Project Title: Refurbish Elevators and Replace Controls

Solicitation Questions and Answers
for
Refurbish Elevators and Replace Controls
Project: 437-22-101, RFP: 36C26324R0021
12/15/2024

Solicitation Questions and Answers (updated 3-26-2024) for
 Refurbish Elevators and Replace Controls
 Project: 437-22-101, RFP: 36C26324R0021

Drawing Number
AD5.20

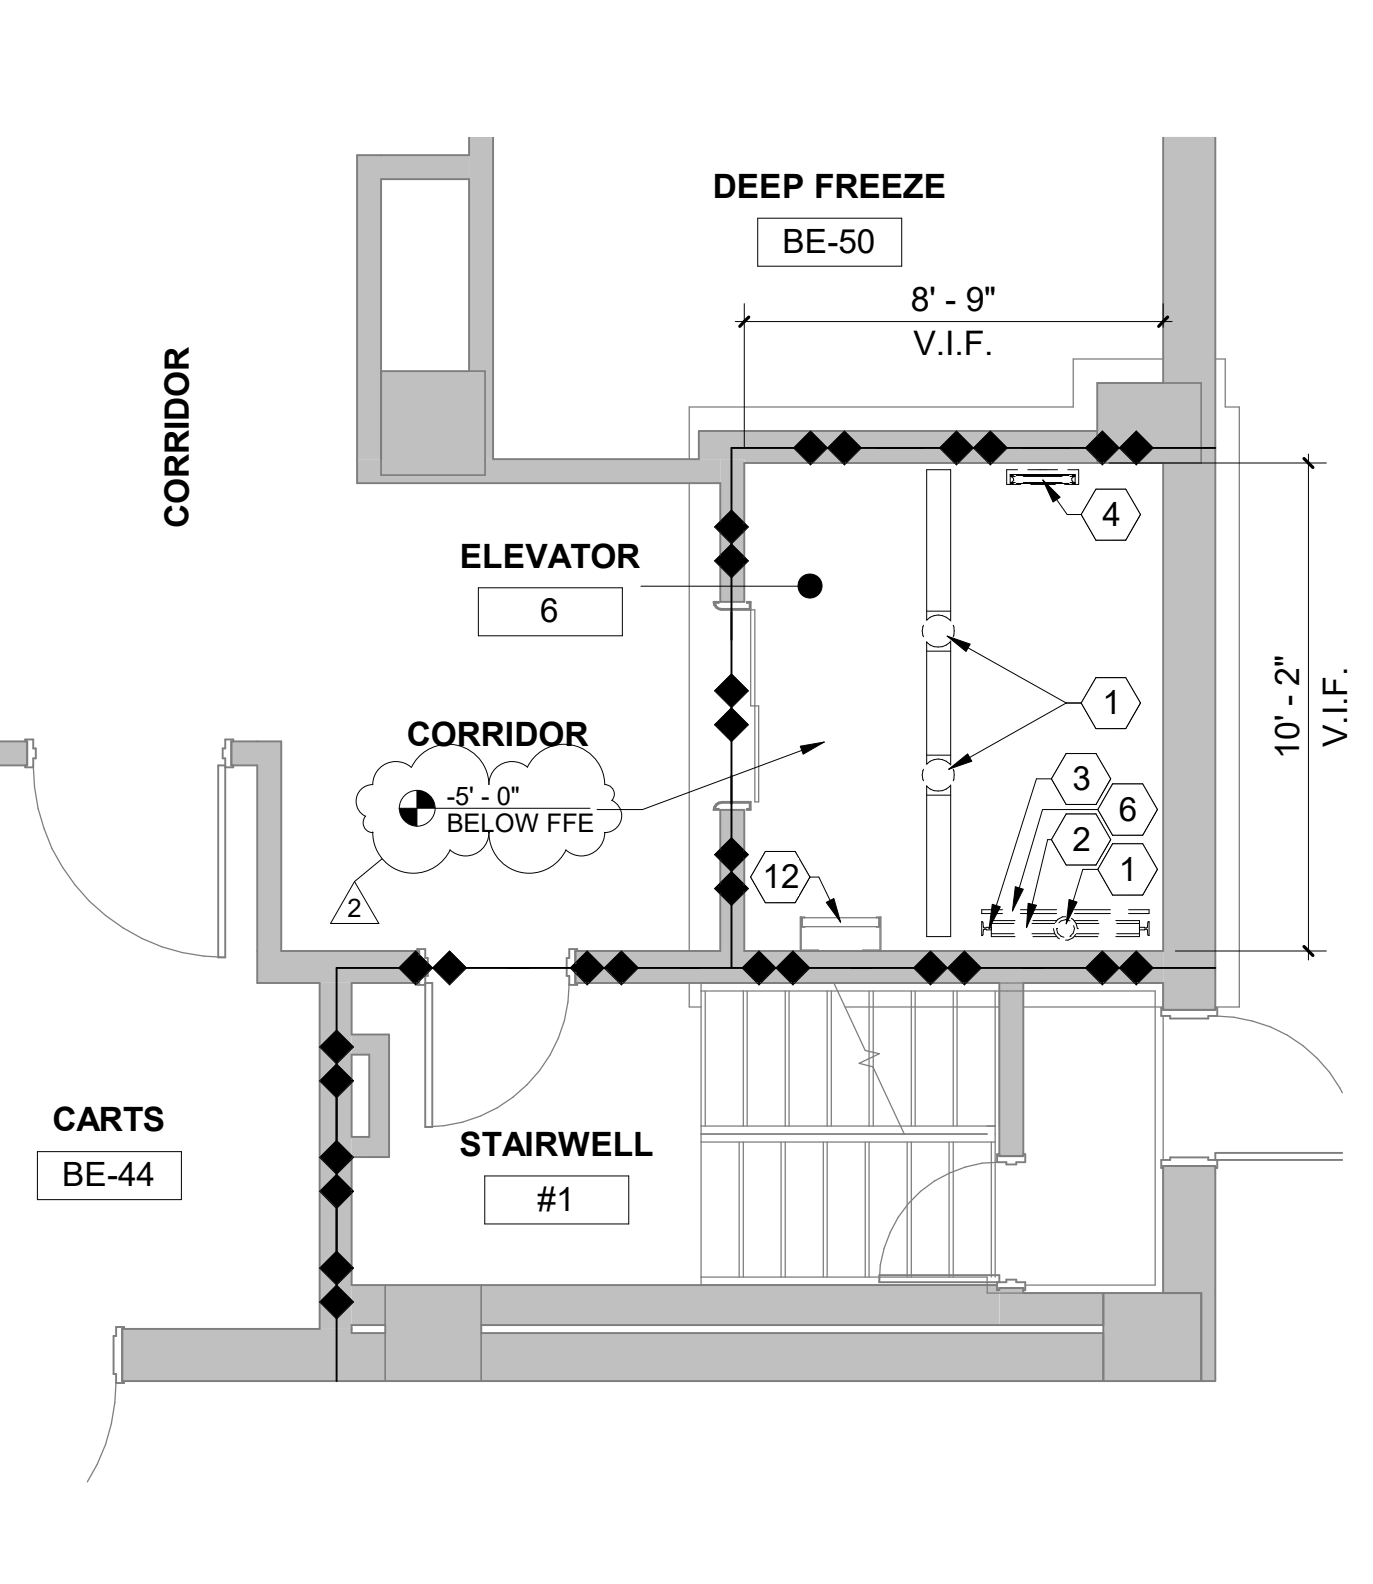
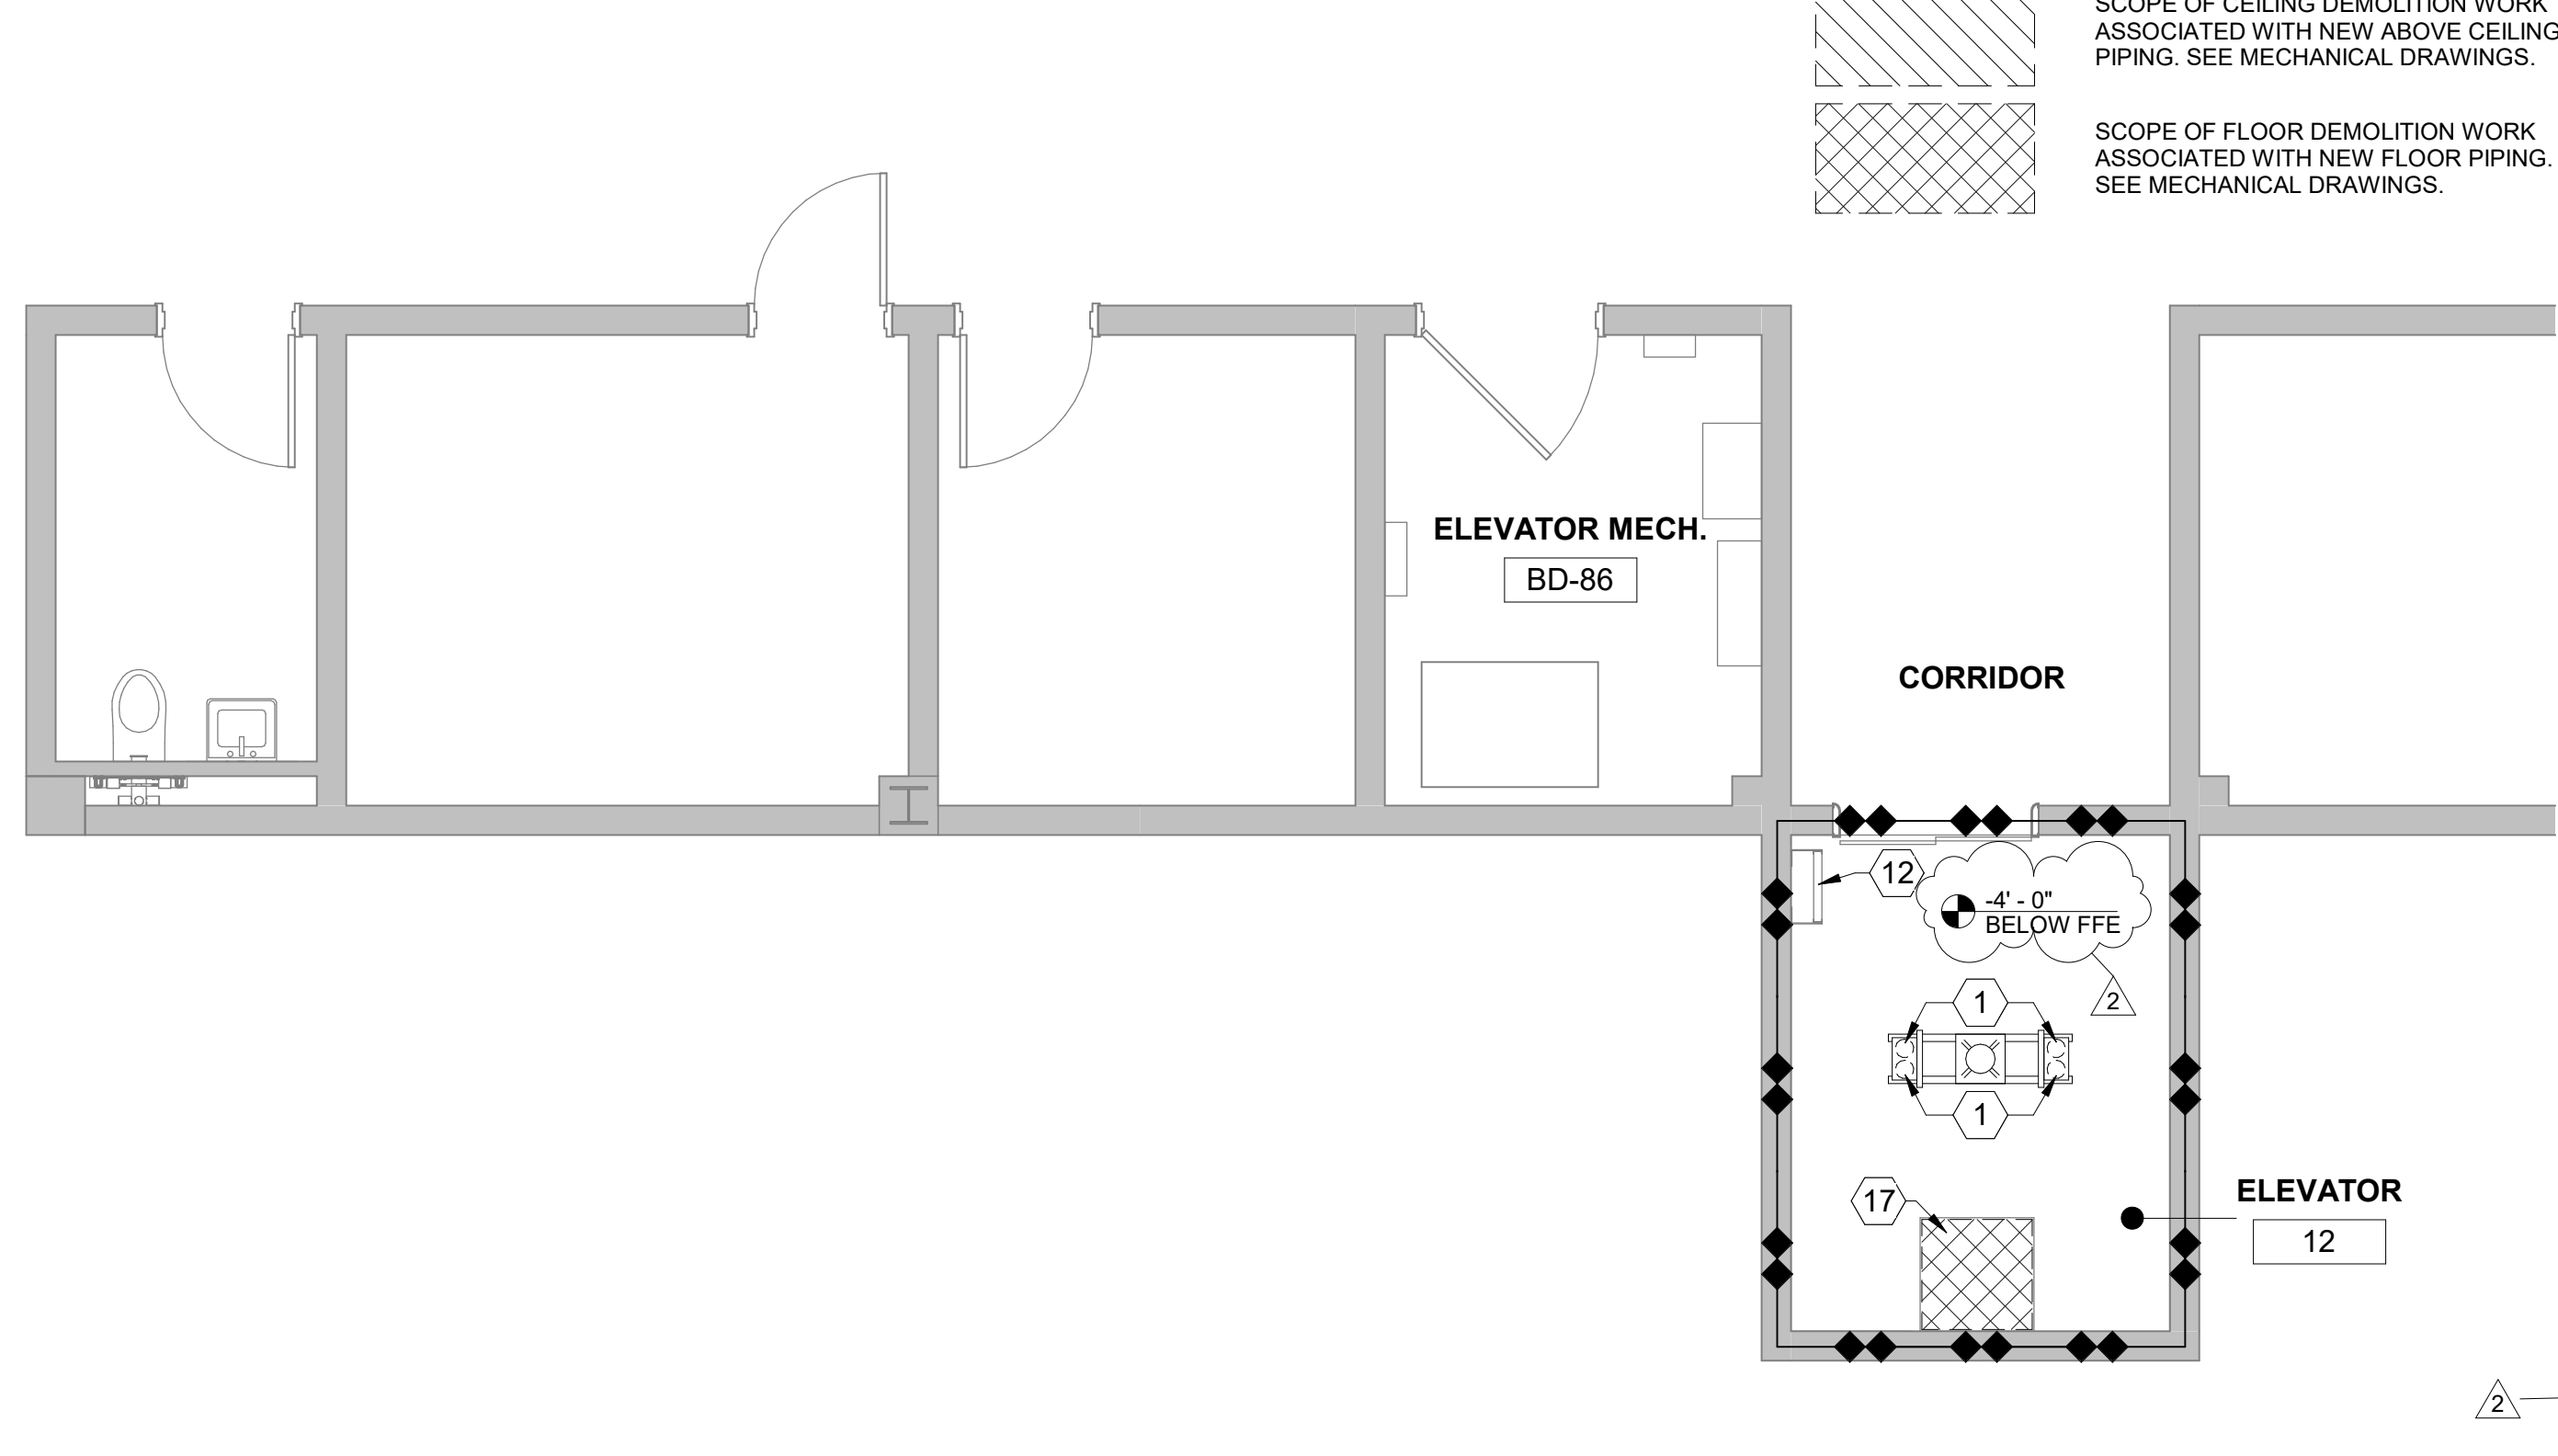
54.	Drawing AD5.20 Key note #12 metal ladders	<p>Per field measurements most ladders in the elevator pit do not meet current code.</p> <p>Are they to remain or be replaced to meet code?</p>	Existing pit ladders to remain. Review on a case-by-case basis will be conducted during construction.

Drawing Sheet AD5.20 ENLARGED PLANS - DEMOLITION – See revised drawing sheet for the adjustment of keynotes # 3, 9, 13 15, 16. Also included is the depth of each elevator pit relative to the floor elevation at the lowest elevator lobby for each hoistway.
